## **Addendum #01 for RFB #951800-01**

Project Name: DOM-IT Jessie Parker South Renovation

Date: April 21, 2026

E102

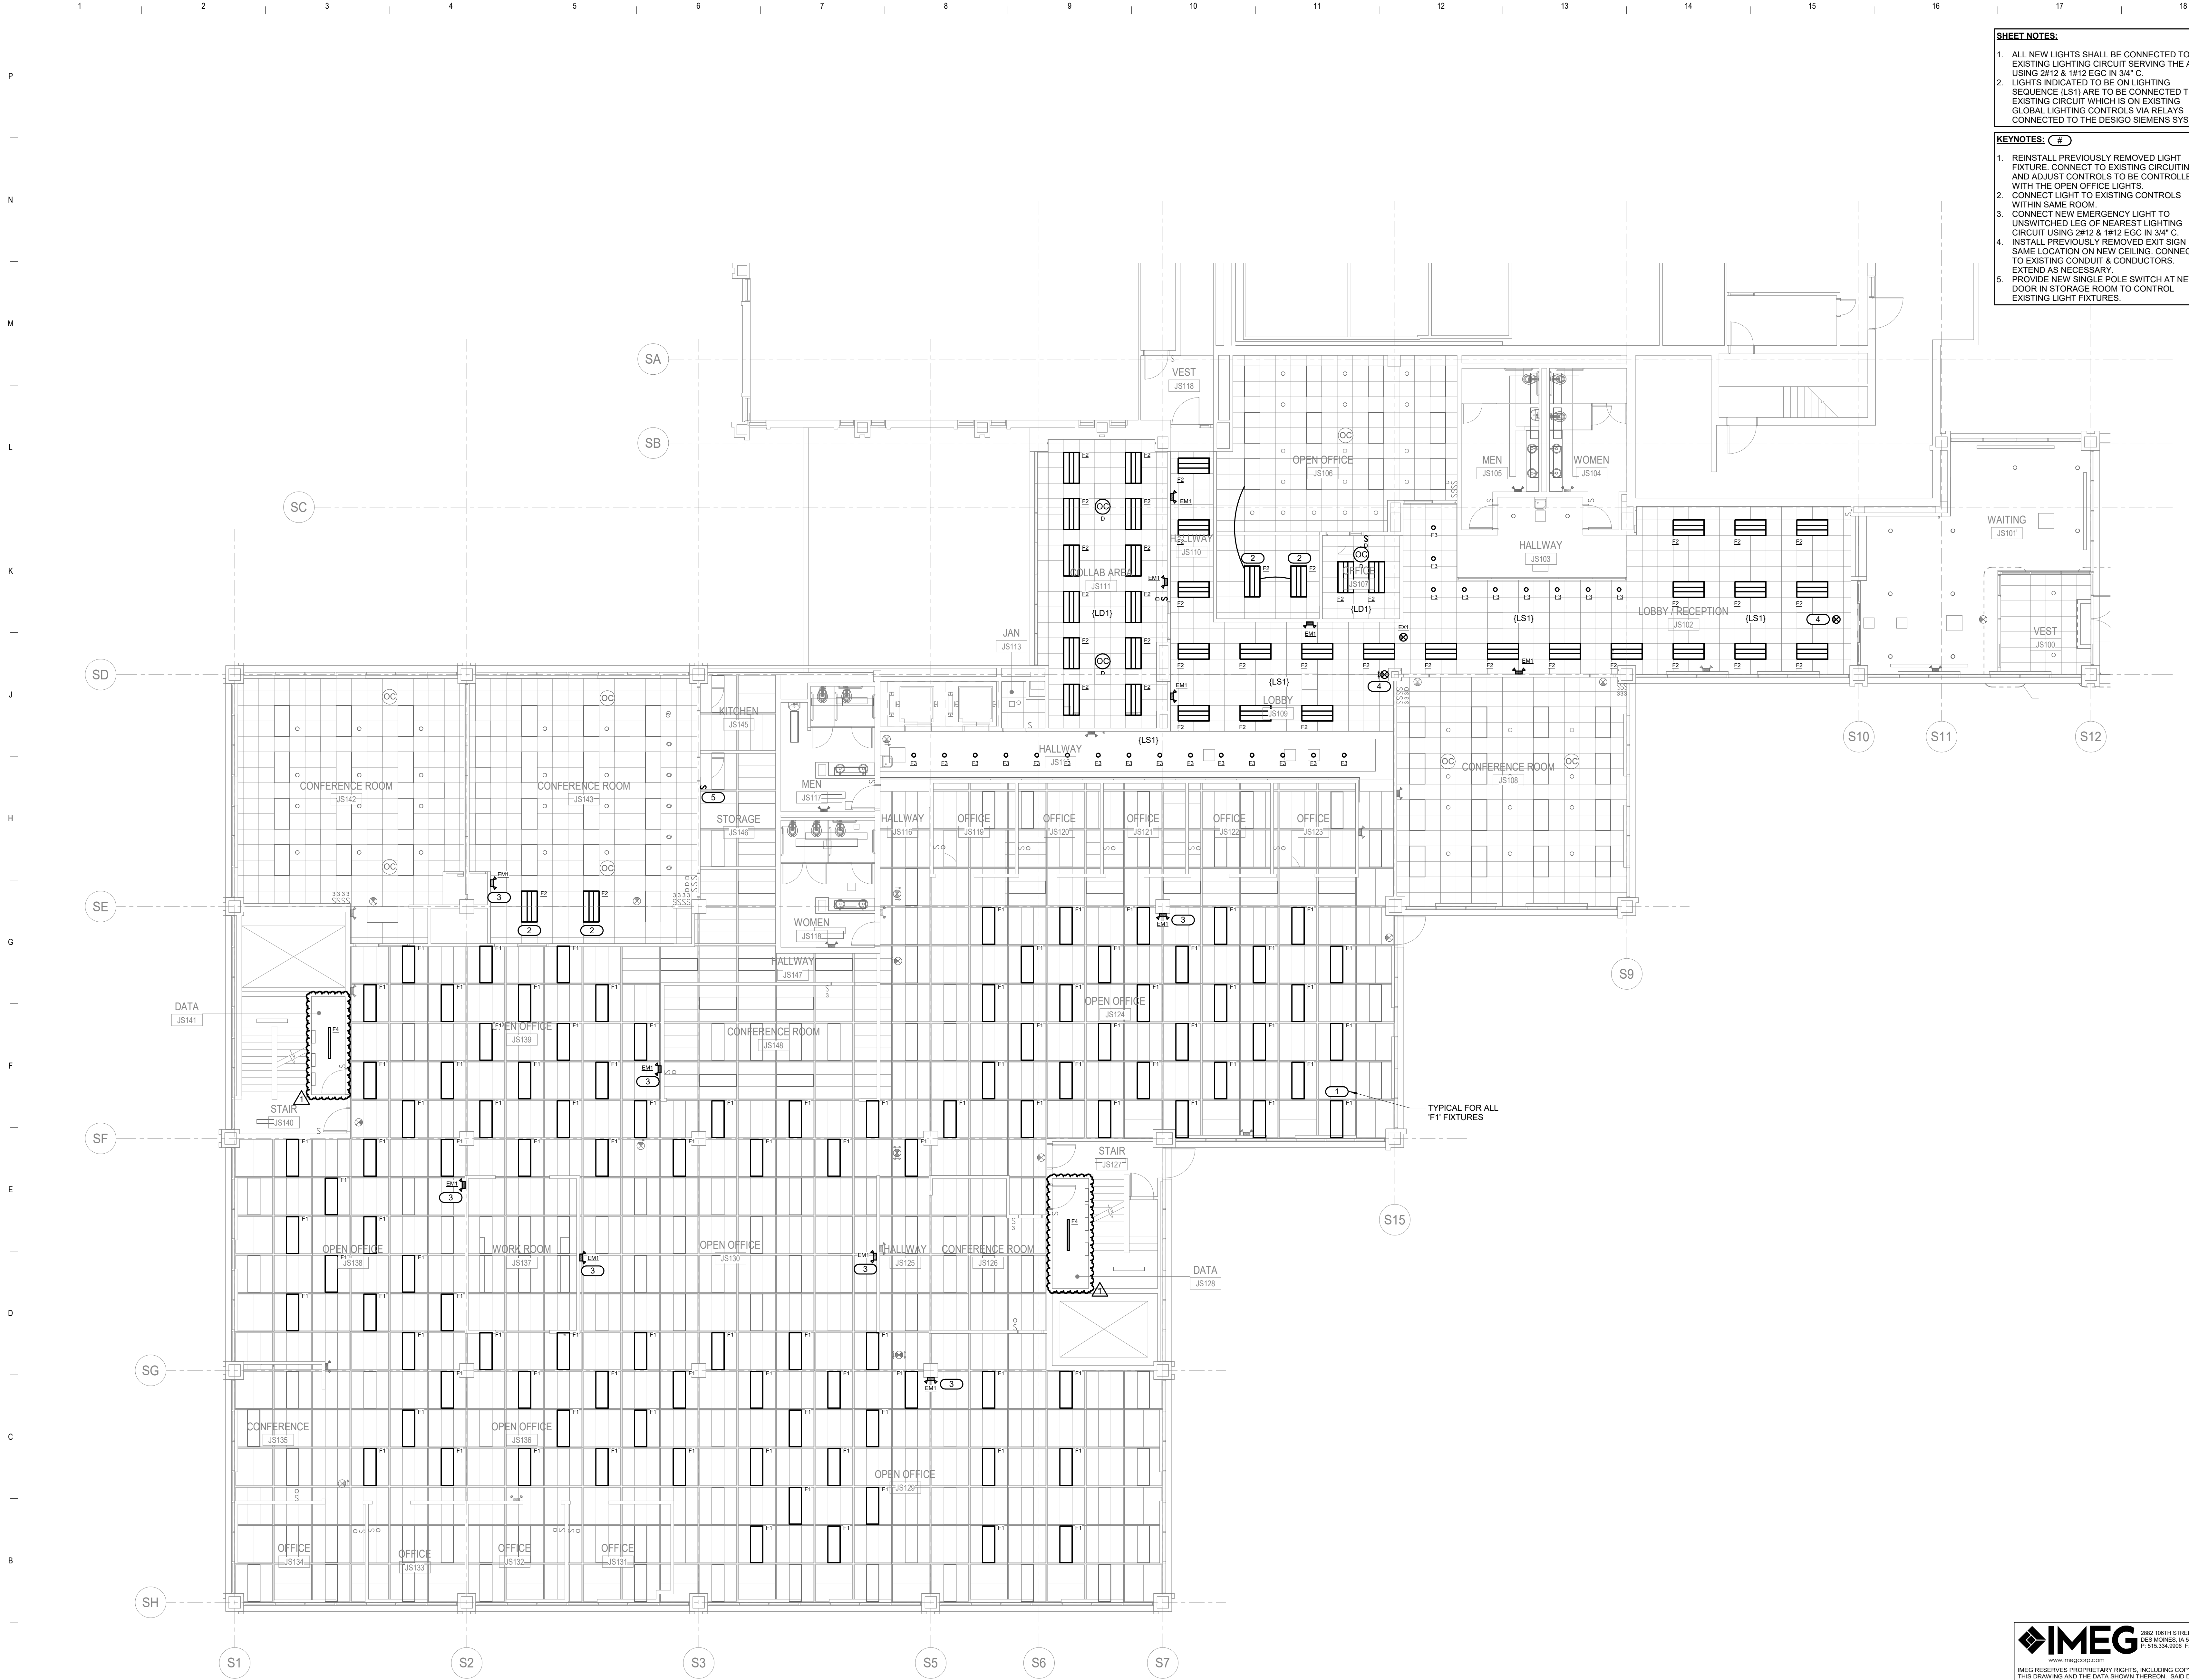
- i. Adds demolition scope of lighting in existing Data Rooms.
6. E102 – Level 2 Demolition Plan - Electrical
  - a. REPLACE original sheet with the revised sheet included in this addendum.

- i. Adds demolition scope of lighting in existing Data Rooms.
7. E211 – Level 1 Floor Plan - Lighting
  - a. REPLACE original sheet with the revised sheet included in this addendum.

E211

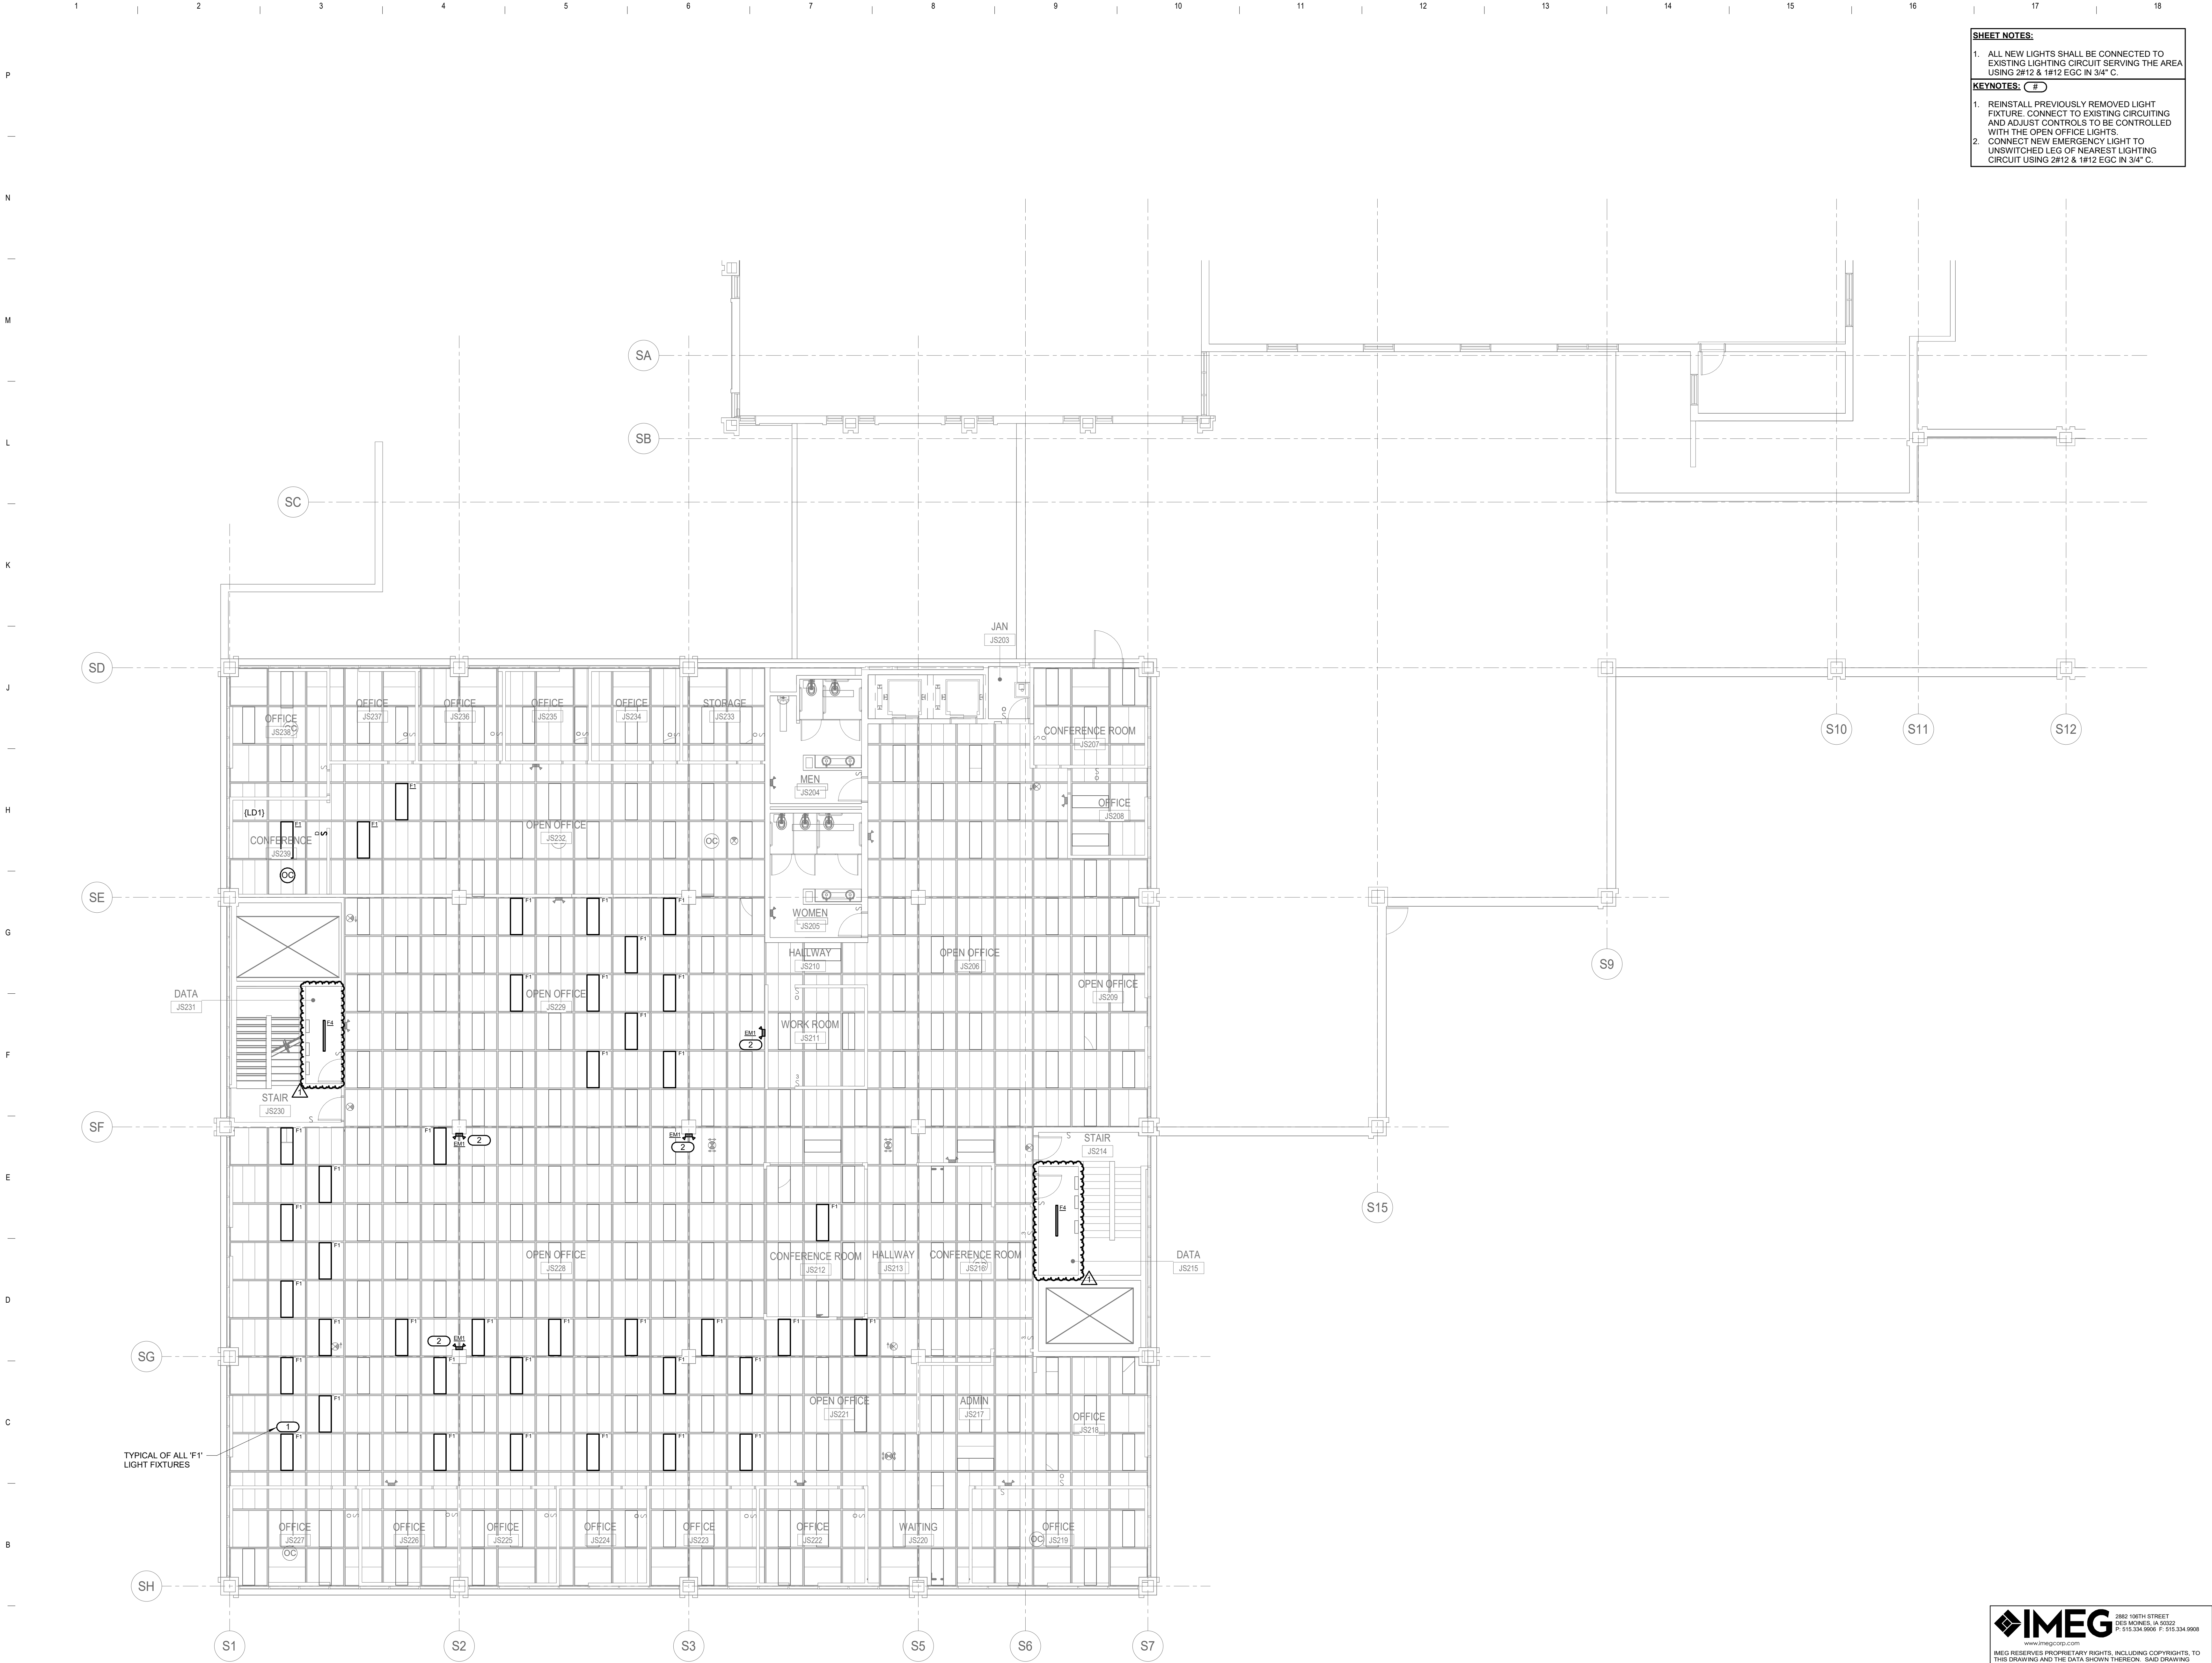
- i. Adds new lighting fixtures in existing Data Rooms.
8. E212 – Level 2 Floor Plan - Lighting
  - a. REPLACE original sheet with the revised sheet included in this addendum.
